CIVIL AND STRUCTURAL ENGINEERING SERVICES, PLLC STATEMENT

ARCHITECTURAL PLANS ARE WERE PREPARED BY OTHERS. CIVIL AND STRUCTURAL ENGINEERING SERVICES PROVIDED STRUCTURAL ENGINEERING DESIGN REVIEW SERVICES. THE PROFESSIONAL SEAL AND SIGNATURE AFFIXED BELOW CERTIFY THAT PLANS AS MARKED/NOTED MEET LOAD BEARING REQUIREMENTS OF NORTH CAROLINA BUILDING CODE, **RESIDENTIAL 2018**

000	Sheet index							
000 001	Cover Notes							
101-A								
101-S								
201 301	Schedules Elevations							
302	Elevations							
401	Foundation Layout							
501	Panel Layout							
601	Roof Framing Layout							
701 702	Building SectionsBuilding Sections							
702	Wall Sections							
704	Wall Sections							
705	Details							
No.	Description Date							
0	Initial Plans 5.4.22							
1	Release 5.18.22							
	Evans							
Ridgeline - B South								
Job Nu								
	Drawing Number 22RI-098							
Project Manager SG Drafter JC								
Diaiter	JC							
Cover								
	000							
Scale

No. 0 1	Description Initial Plans Release	Date 5.4.22 5.18.22
	Evans	
	Ridgeline - B South	
Drawi	Job Number22031Drawing Number22RI-098Project ManagerSG	
Drafte	Drafter JC	
	Foundation Layout	
	401

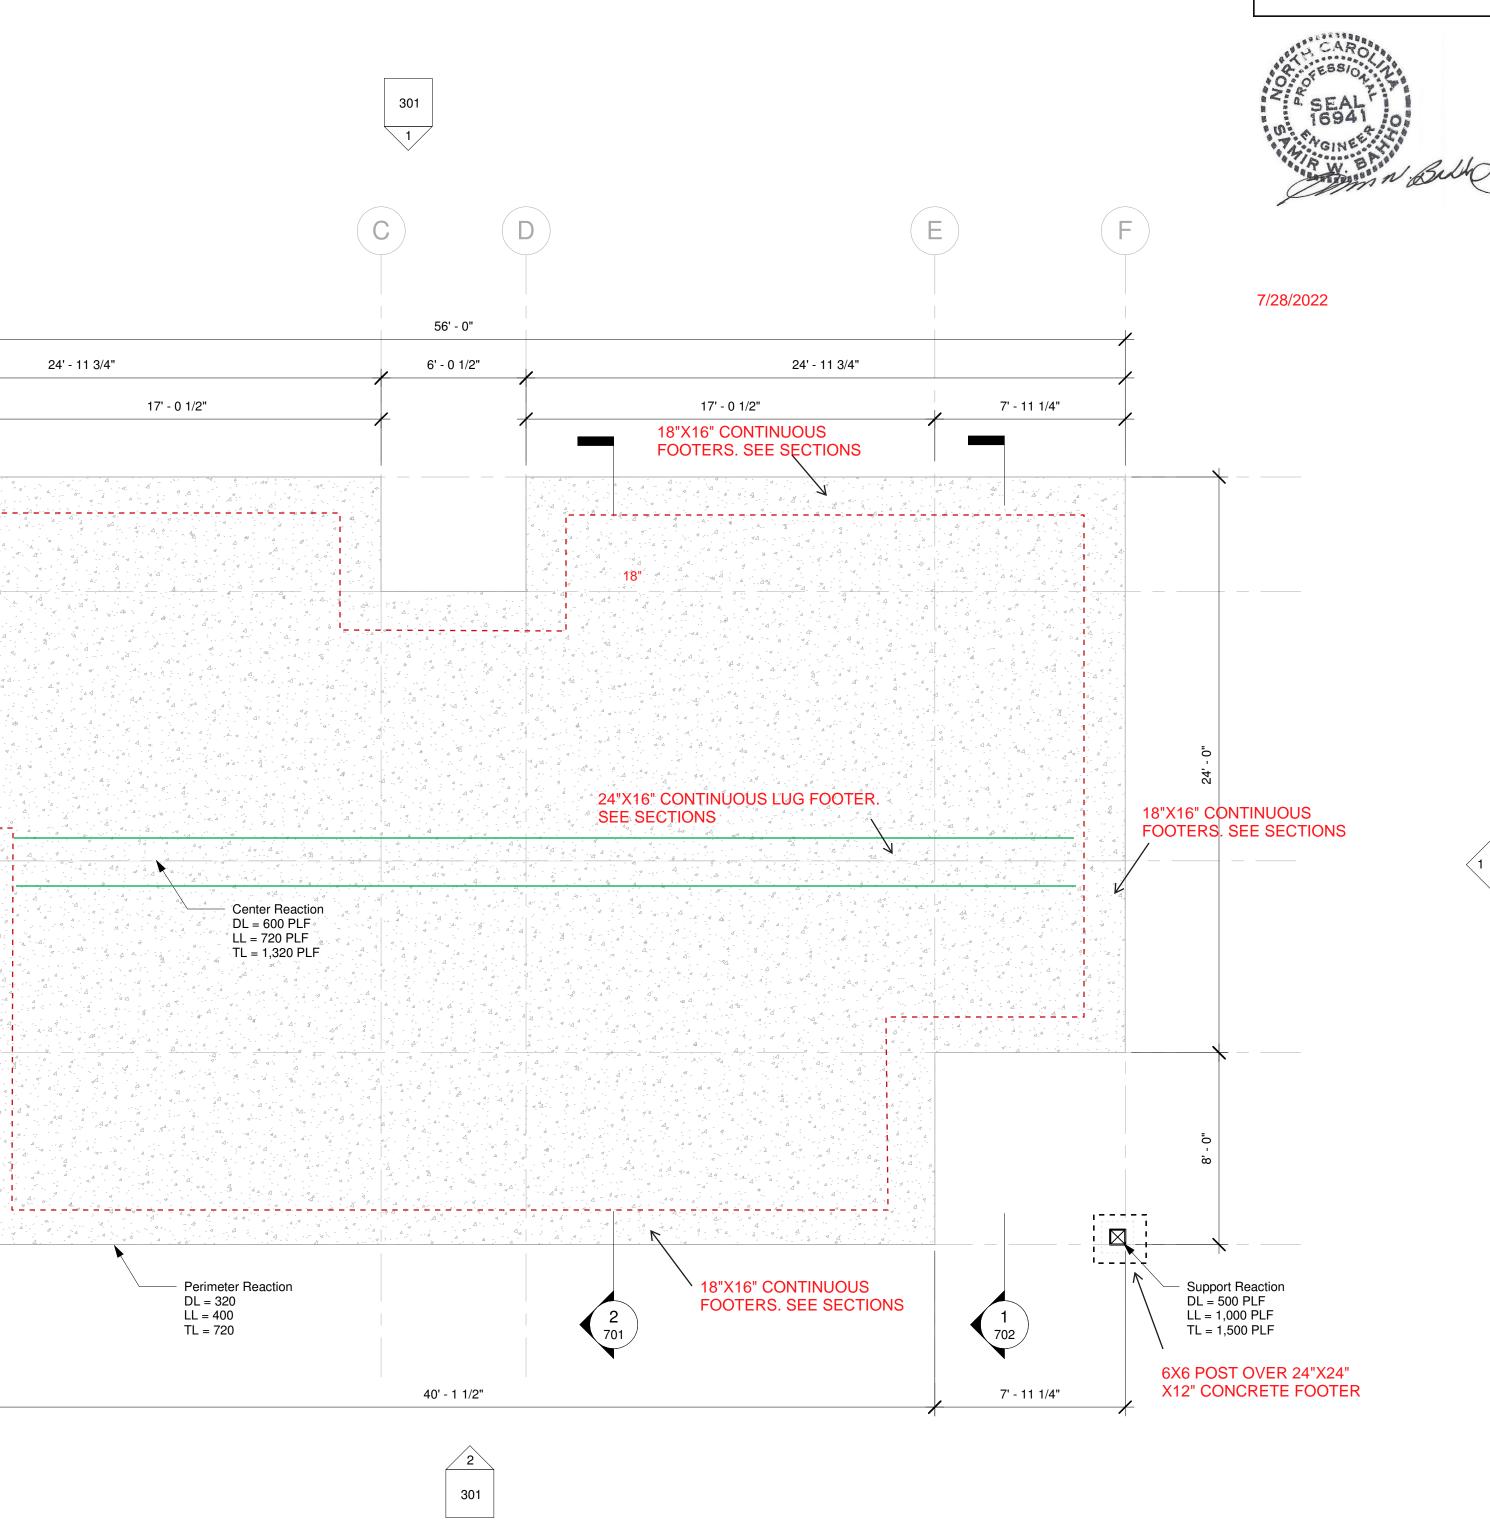
NOTE: FOUNDATION SLAB SHALL BE CONSTRUCTED AS FOLLOWS: 4" CONCRETE SLAB 3000 PSI STRENGTH WITH FIBERGLASS REINFORCEMENT OVER MIN 6 MIL VAPOR BARRIER OVER 4" WASHED CRUSHED STONE 67 OVER MECHANICALLY COMPACTED EARTH. VIRGIN UNDISTURBED SOIL SURFACE IS ACCEPTABLE

NOTE: FOOTERS SHALL BE CONTINUOUS ALONG THE OUTSIDE PERIMETER OF THE SLAB. DIMENSIONS OF FOOTERS SHALL BE AS SHOWN ON THE PLAN SECTIONS. FIBERGLASS CONCRETE WITH 3000 PSI STRENGTH IS PERMISSIBLE.

No. 0 1	Description Initial Plans Release	Date 5.4.22 5.18.22
	Evans	
Ridgeline - B South		
	g Number 2 Manager	22031 22RI-098 SG JC
Building Sections		
701

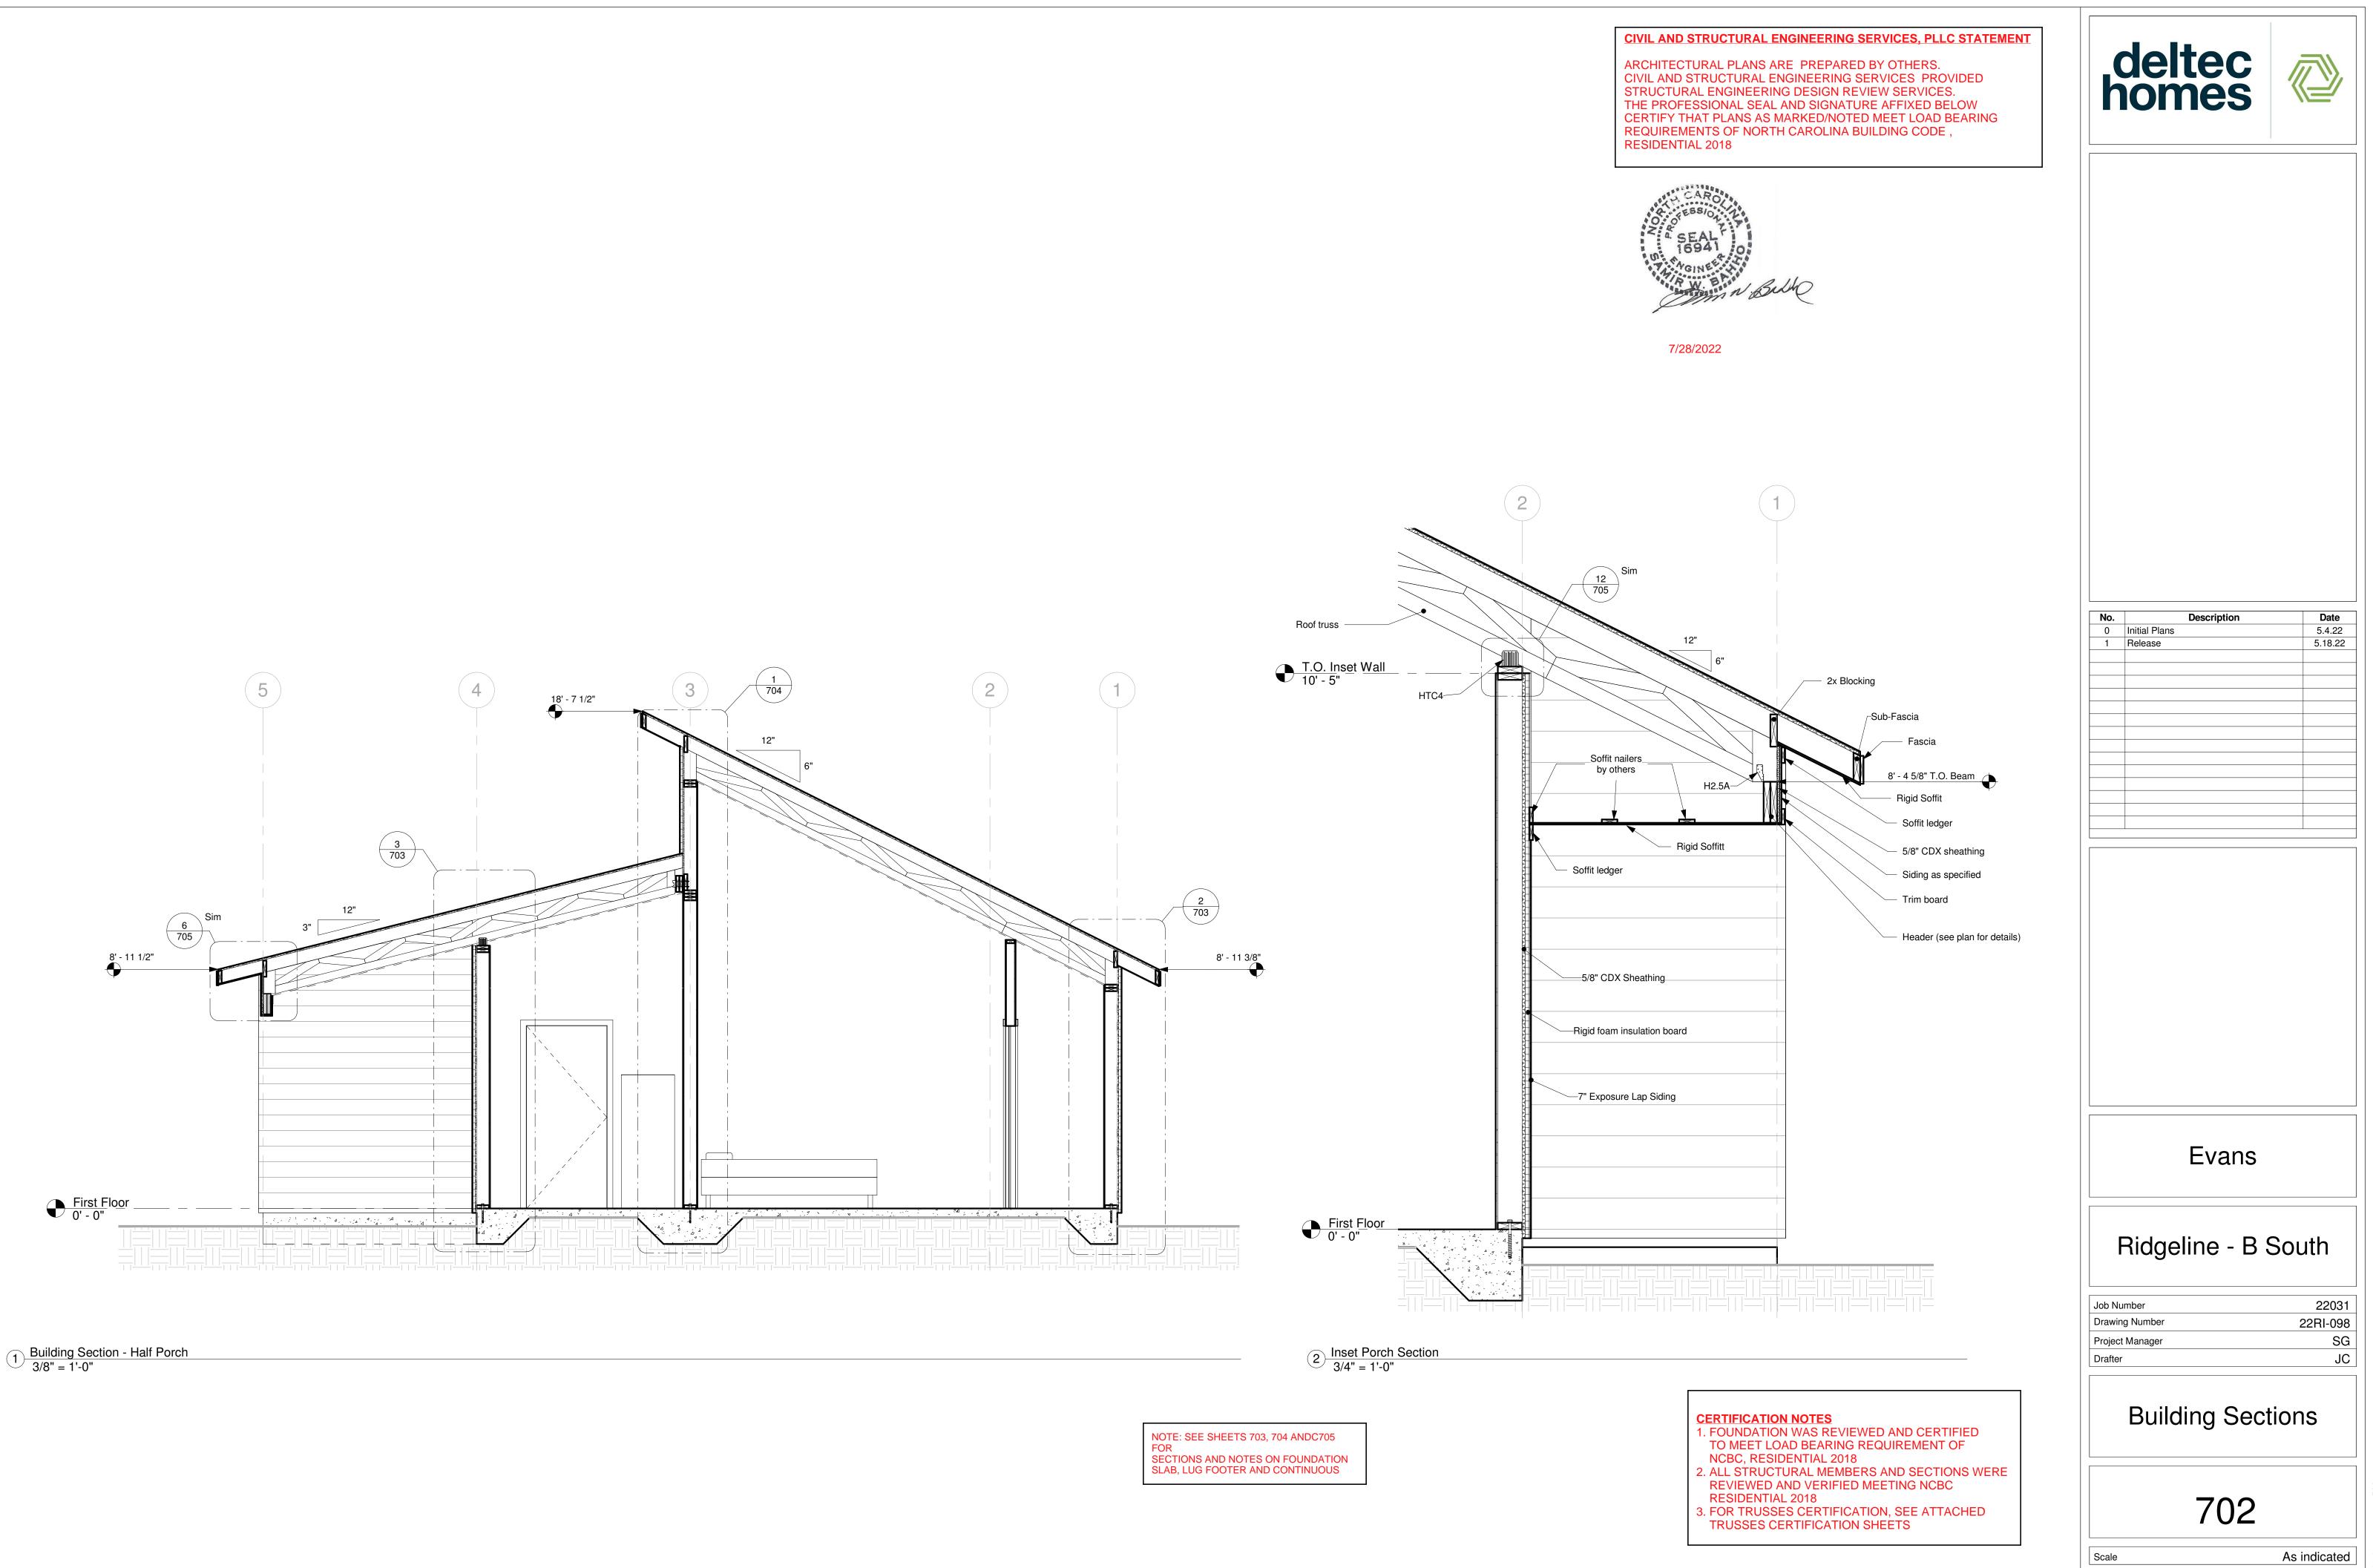
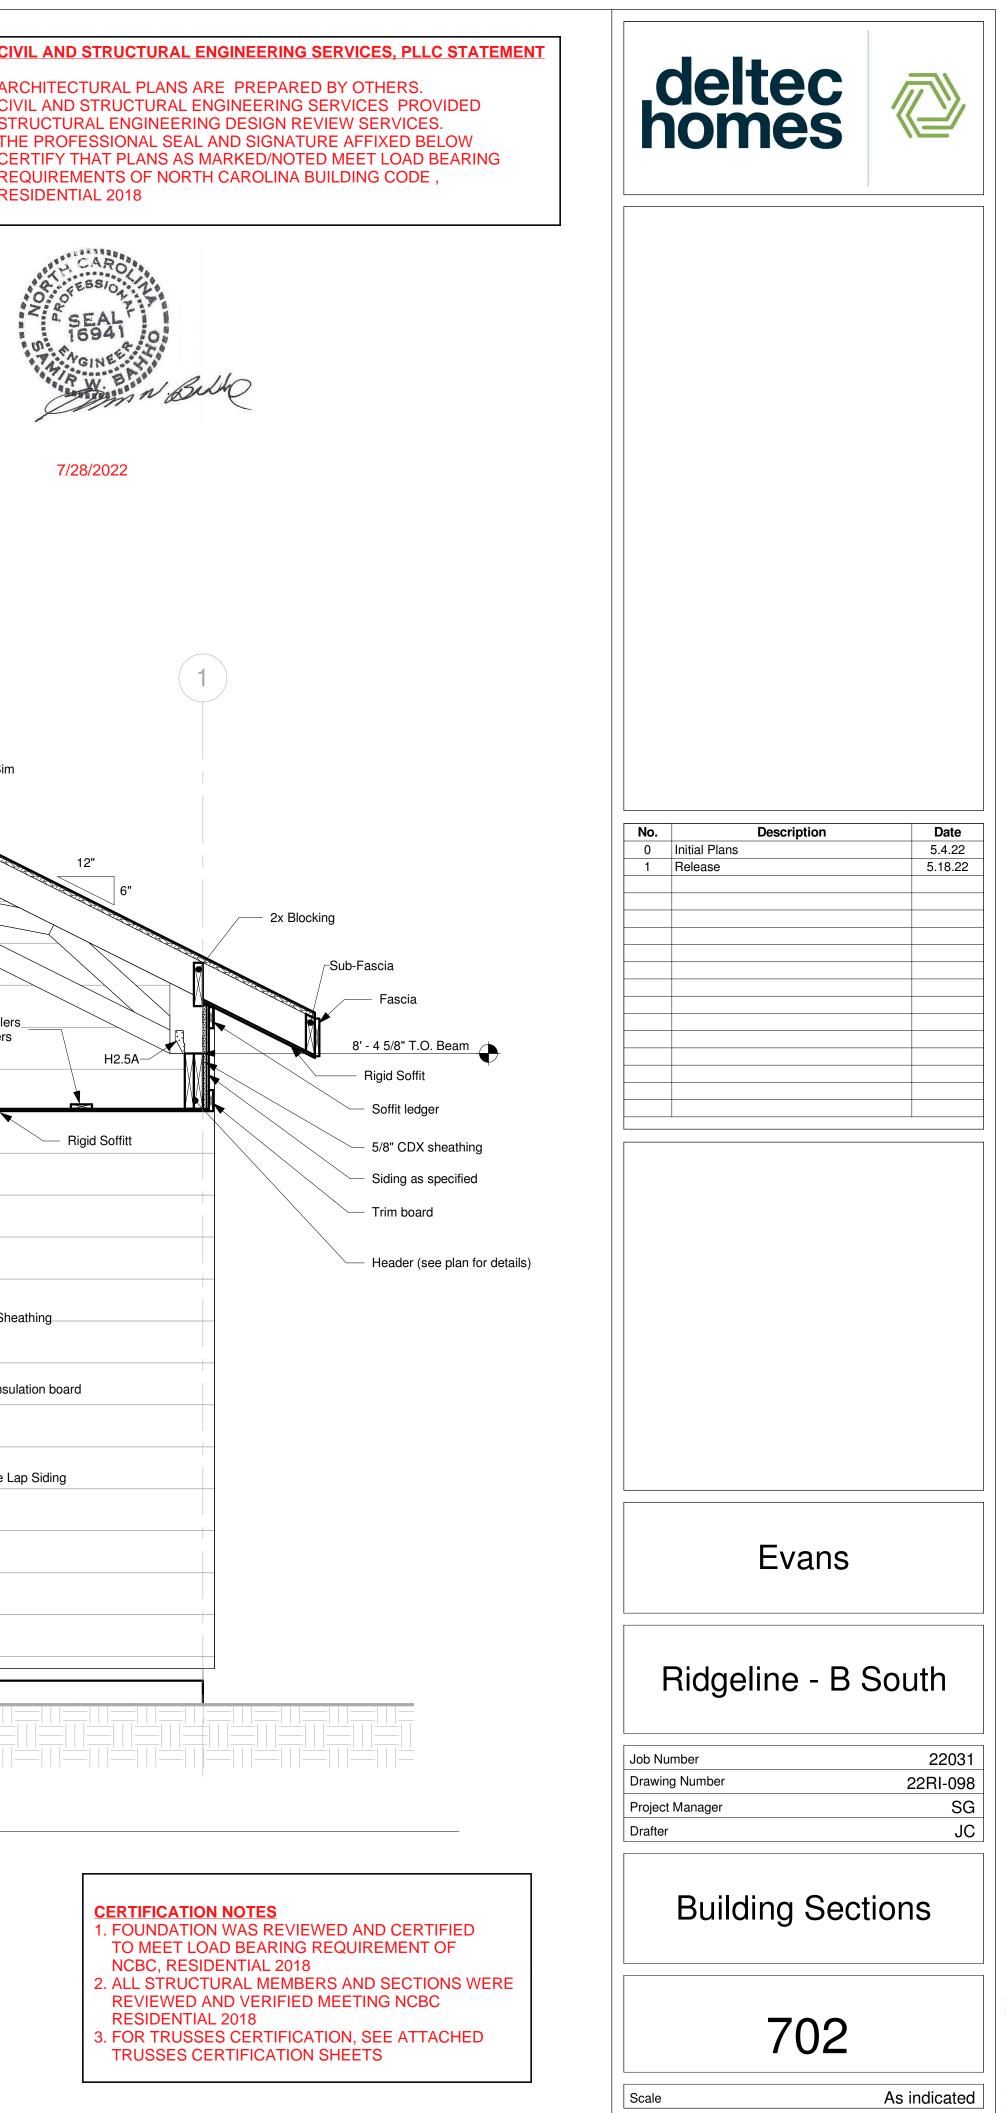
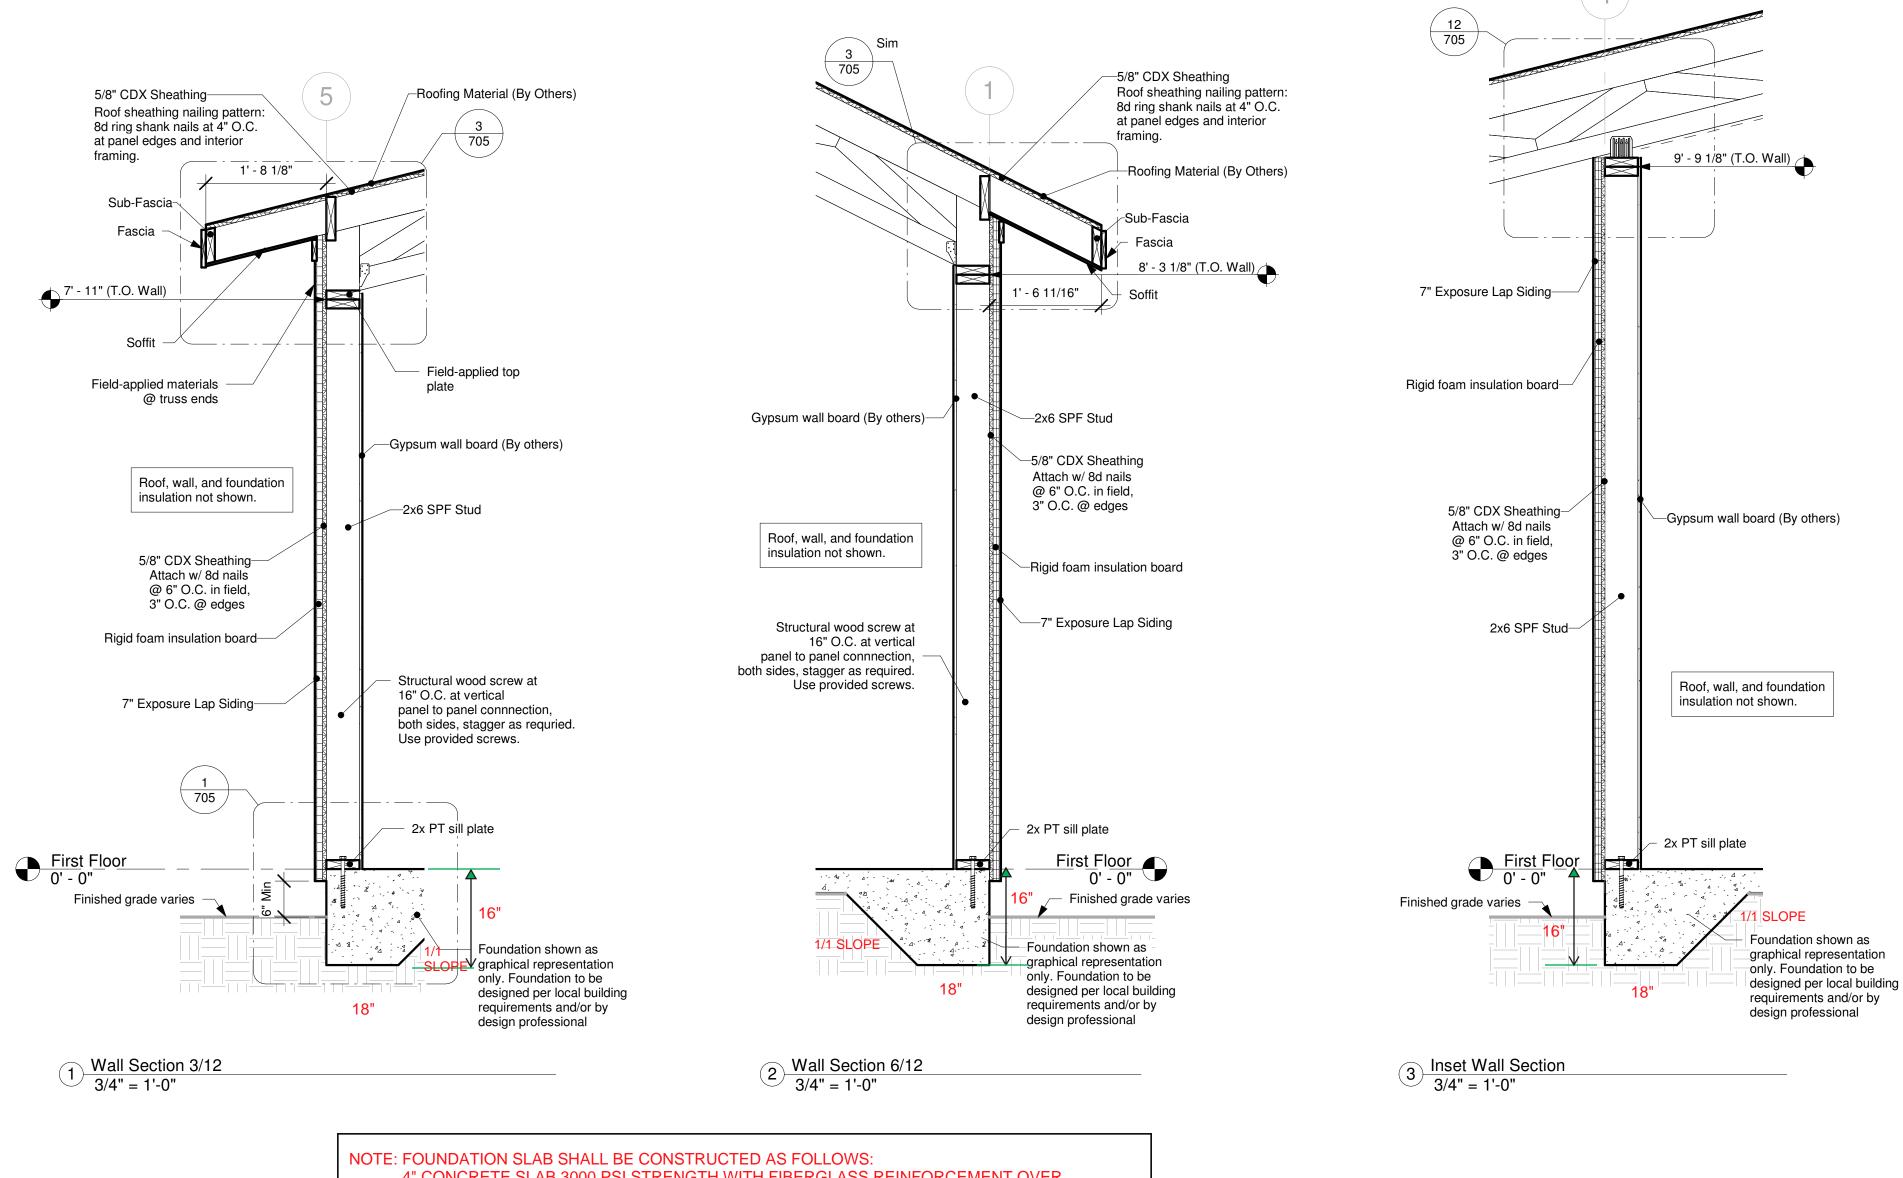
NOTE: FOOTERS SHALL BE CONTINUOUS ALONG THE OUTSIDE PERIMETER OF THE SLAB. DIMENSIONS OF FOOTERS SHALL BE AS SHOWN ON THE PLAN SECTIONS. FIBERGLASS CONCRETE WITH 3000 PSI STRENGTH IS PERMISSIBLE.
